Notice of Allowability

10/781,514

EXAMINER'S AMENDMENT

FIG. 4

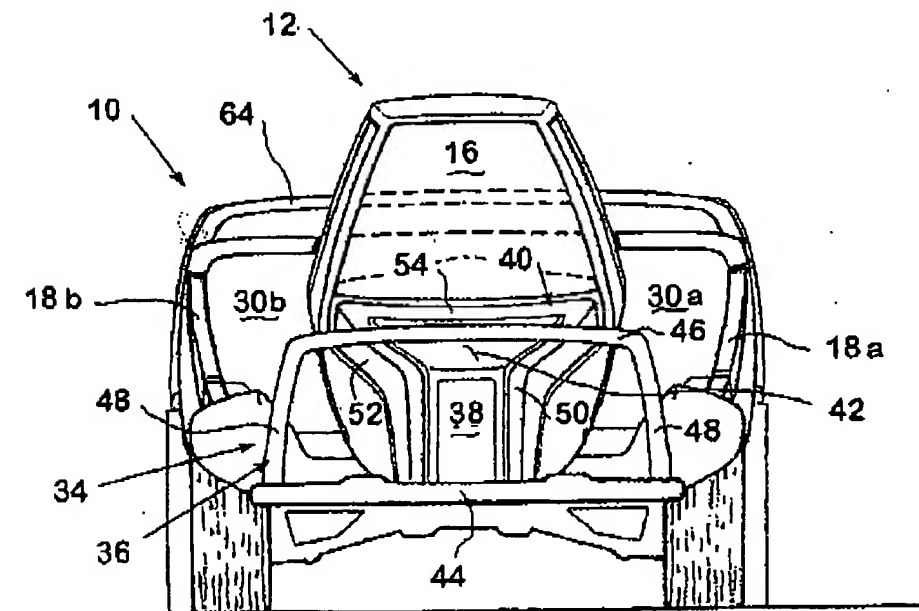
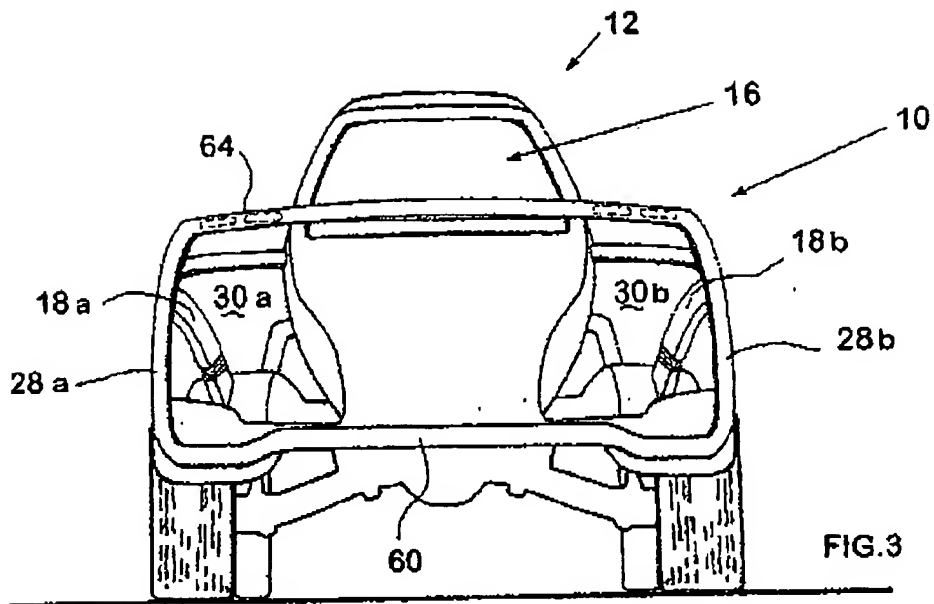
Figure 7 has been deleted from the sheet containing Figures 3 and 4.

New Figure 8 has been added.

In order to avoid abandonment of the application, applicant must make these above agreed upon drawing changes.
